Your Ref
Y/49/18/PL
Our Ref
PLAN-023895
Date
16/08/2018

Proposal: Development of 10No. residential properties & associated infrastructure. This application is a Departure from the Development plan Site: Land East of North End Road, Yapton, BN18 0GA. Y/49/18/PL

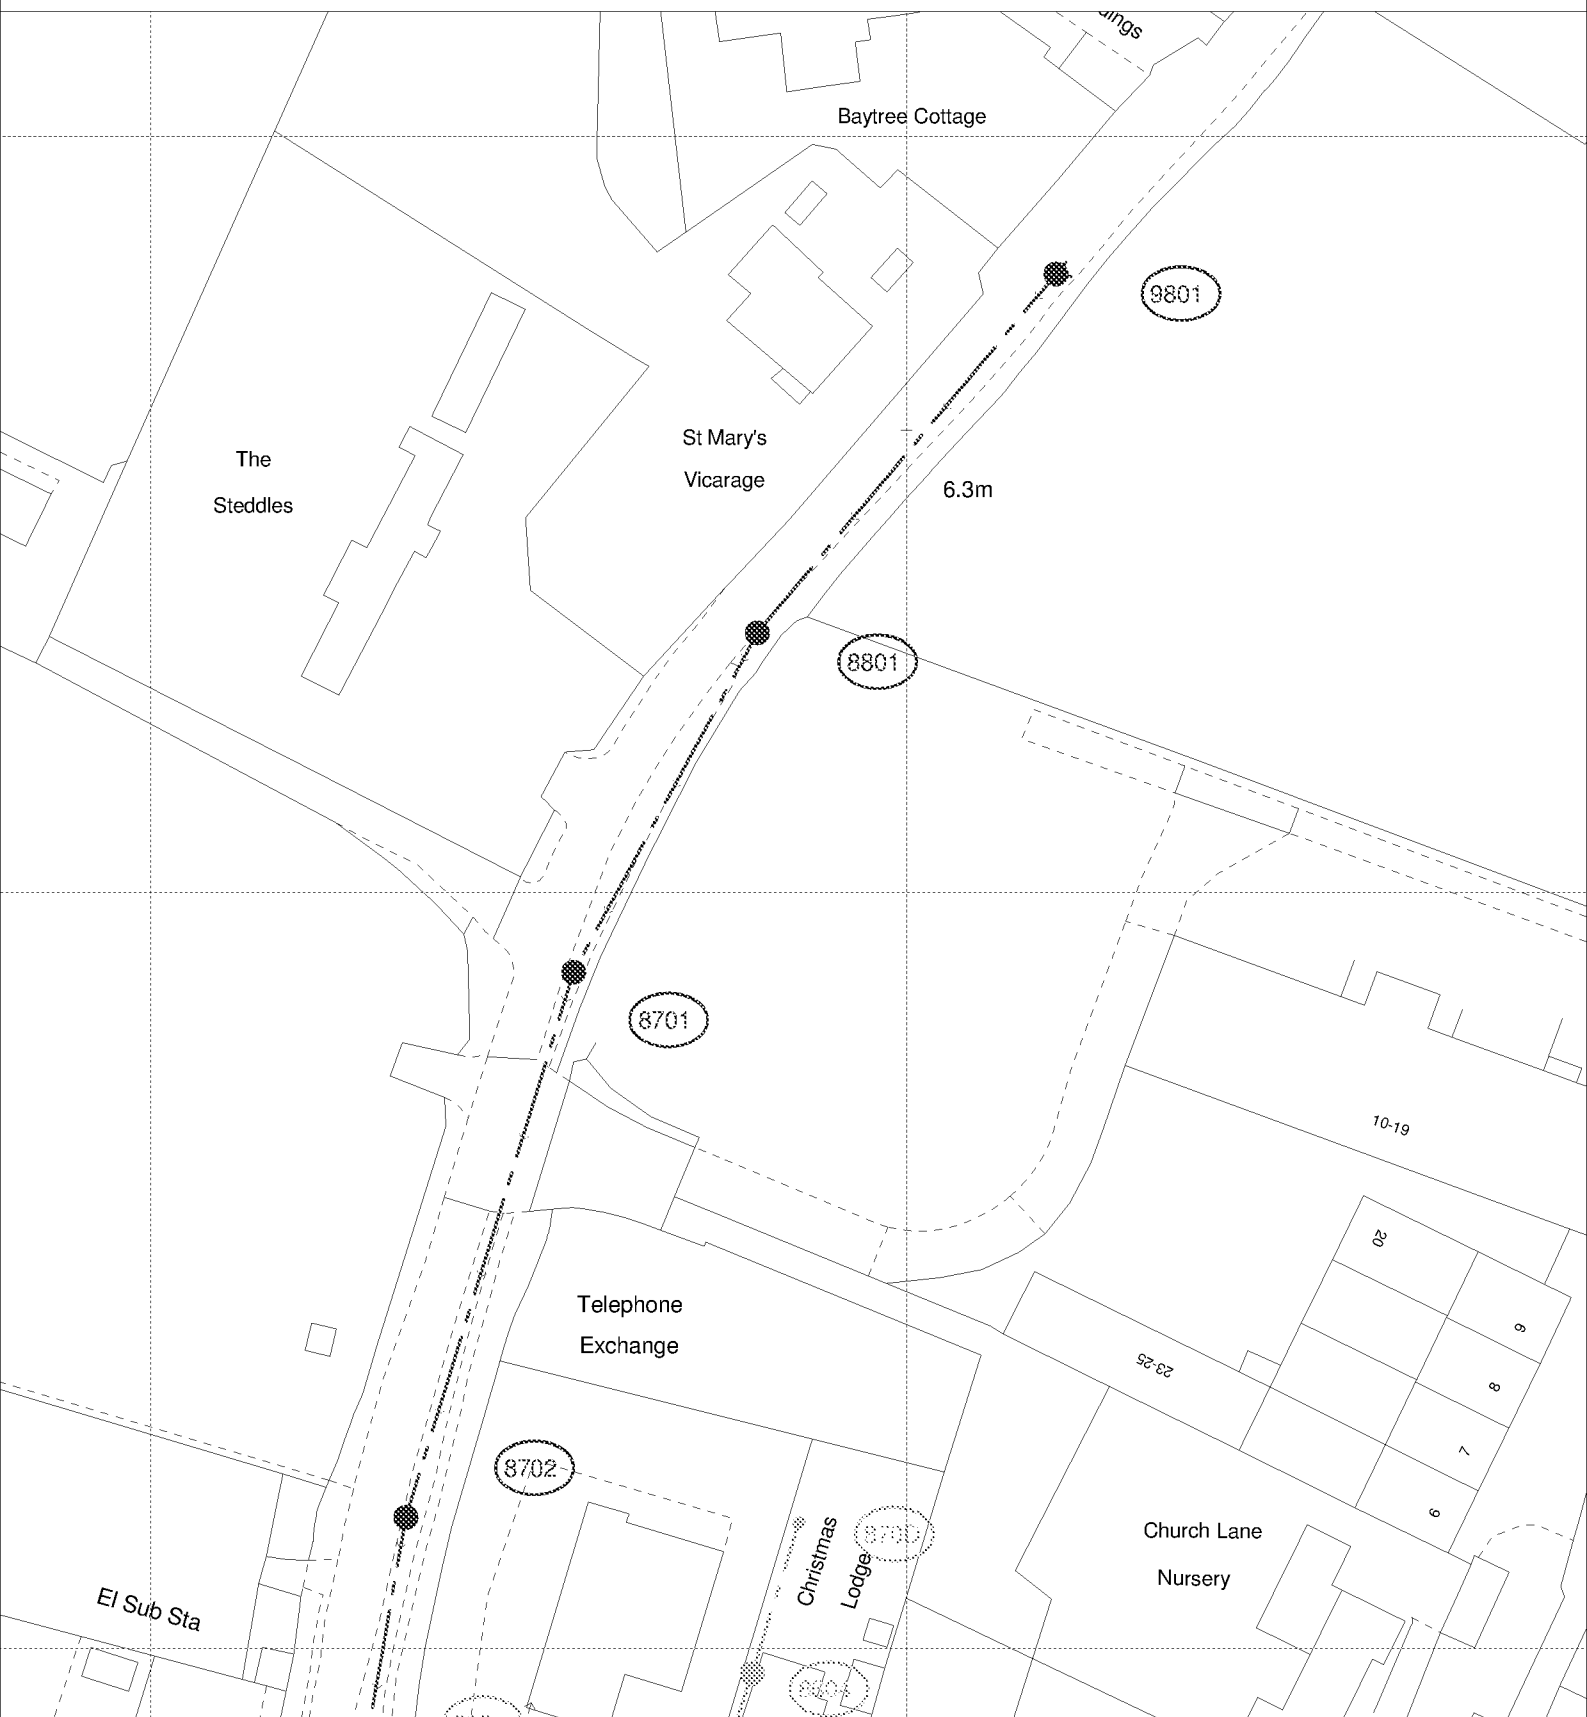
Due to surface water inundation issues in the Lidsey Catchment "The applicant is advised to adopt, where appropriate, the measures in the table "Practical measures to reduce the potential impacts of development".

Developer should look to protect the public sewerage system from inundation and infiltration, which contribute to flooding in unfavourable conditions.
